Technical Service Bulletin: tsb020001

Released Date: 09-Oct-2003

CENSE™ Phase 1.5 Harness Repair Instructions

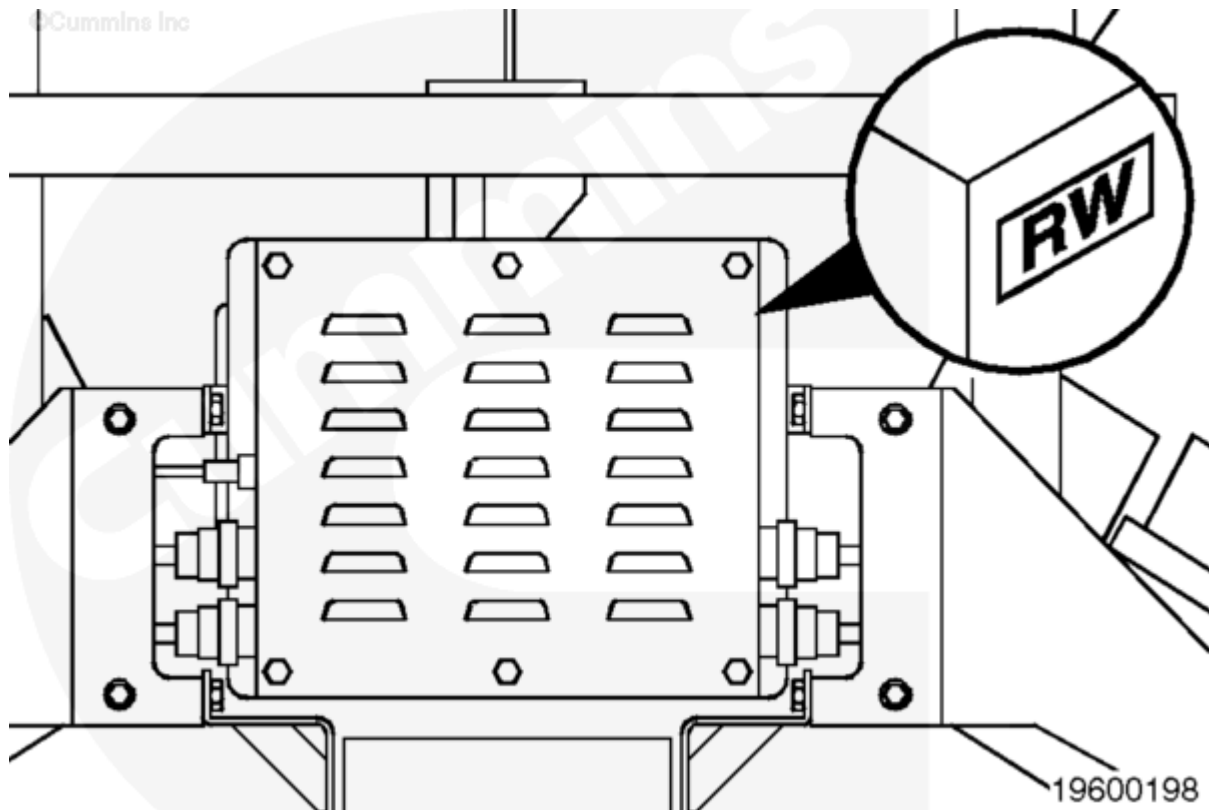
Reconnect the connector with the 4-mm allen key.

Torque Value: 3 n•m [27 in-lb]
